Response to Submissions

State Significant Development Application (SSD 8529)

Commercial Building C1
Barangaroo South

Submitted to Department of Planning and Environment
On behalf of Lend Lease (Millers Point) Pty Ltd

Figure 1 - Calculation of area of Scotch Row open to the sky

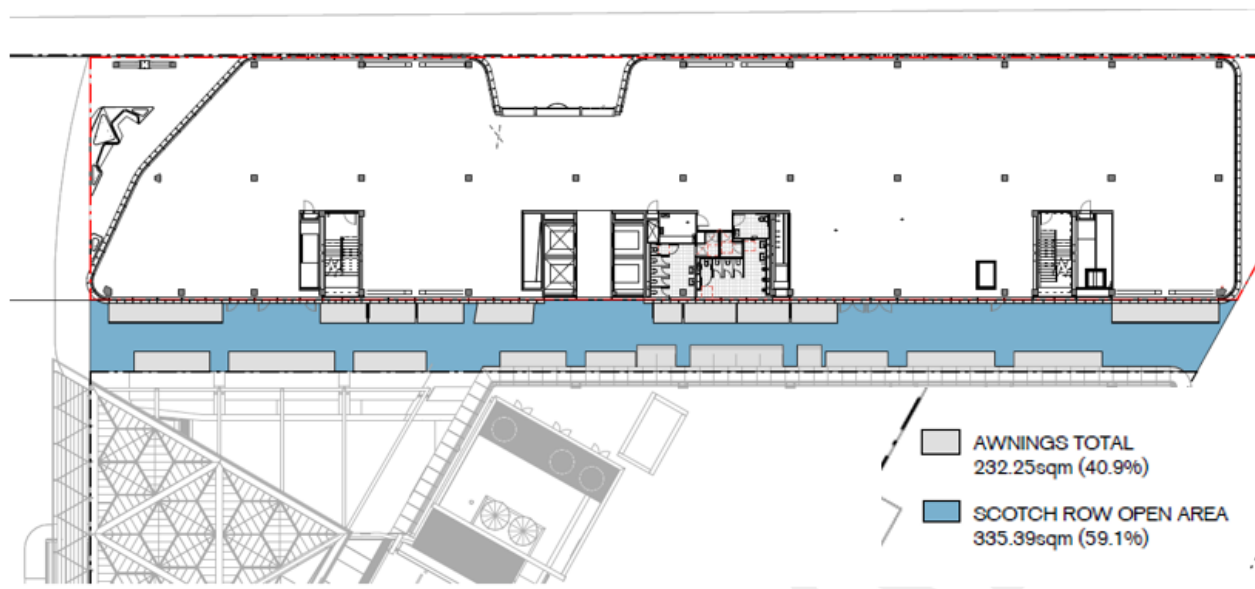
'Control 5 – Ground Floor Permeability and Accessibility of the Public Realm' includes a standard that Scotch Row must be not less than 50% open to the sky. Fixed awnings have been introduced to the Scotch Row building elevation in order to provide an environment wind condition suitable for pedestrian comfort (refer to **Section 5.7** below). The proposed increased width of the awning on Scotch Row will maintain compliance with this standard as it projects to only 2 metres and is not continuous along the full length of the building. The awning on Tower 1 opposite is also not continuous for the full length of the building and projects to varying depths of no more than 2 metres, allowing sunlight into Scotch Row. **Figure 1** demonstrates that notwithstanding the increased awning area, at least 50% of the area of Scotch Row remains open to the sky.

Detailed wind tunnel testing has been completed to analyse the pedestrian wind conditions for Scotch Row (submitted at **Appendix G**). This testing confirmed that based on the architectural design, as lodged, Scotch Row would not maintain a wind condition consistent with the pedestrian comfort criteria. Therefore, additional scenarios have been tested to analyse the optimal solution, balancing wind conditions with the 'openness' of Scotch Row as per the Barangaroo South Built Form and Urban Design Controls. The wind tunnel testing utilised a 2.2 metre wide awning, which found that the pedestrian comfort criteria was achieved. The review at **Appendix G** confirms that a 2 metre wide awning to portions of the western elevation would also achieve both the pedestrian comfort criteria and the requirement for 50% of Scotch Row to be open to the sky (refer to **Figure 1** previously).

Figure 2 – Active street frontage

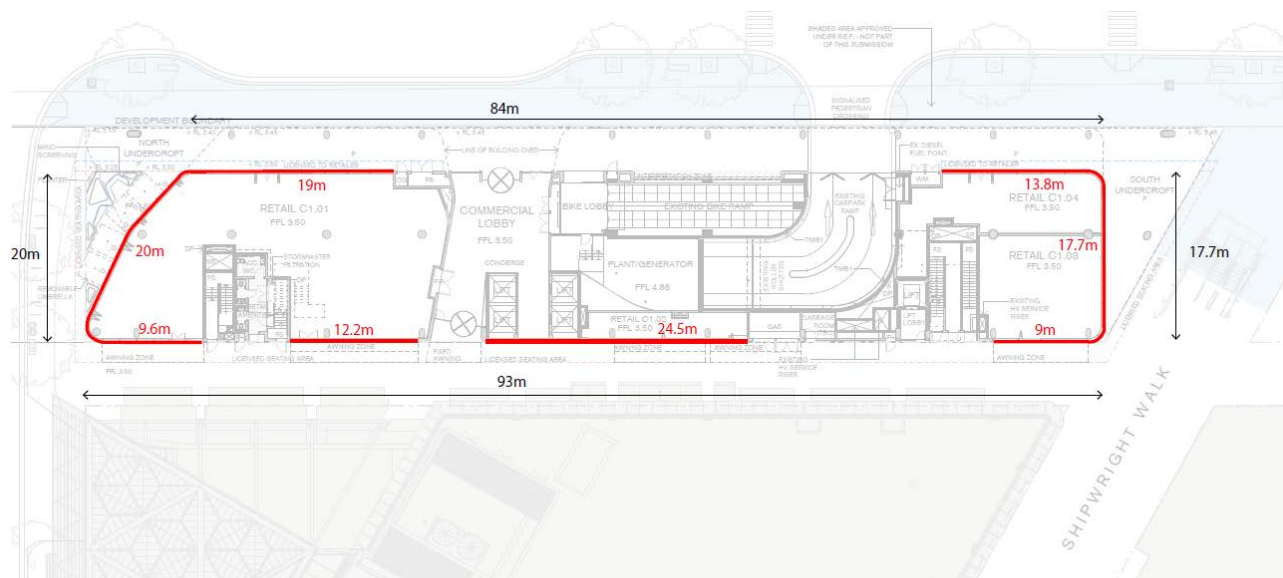
'Control 8 – Active Streetfronts' contains a standard that at least 60% of the ground level is to be active on the primary street wall facades. The proposed design of the building incorporates at least 58% of the ground level as an active frontage. The diagram at **Figure 2** below shows that building entrances to internal areas such as office lobbies, exists and service areas or loading docks have not been counted towards the 60% requirement. This minor numeric variation is driven by the loss of active frontage caused by the existing basement access ramp and existing established services operating on the C1 Plot, approved via the earlier basement application being MP10_0023.

Opportunities to activate the street frontages on all sides of the building have been maximised and the proposed design is considered acceptable on the basis that the ground floor uses will contribute to a vibrant public domain. This is consistent with the objective of the control, which is 'to ensure a vibrant public domain will be created at street level'. Commercial Building C1 is one component of the overall Barangaroo South precinct and it is considered that this minor variation will not detrimentally impact the high level of activation and amenity that is currently provided within the precinct and will be further enhanced upon completion of the building.
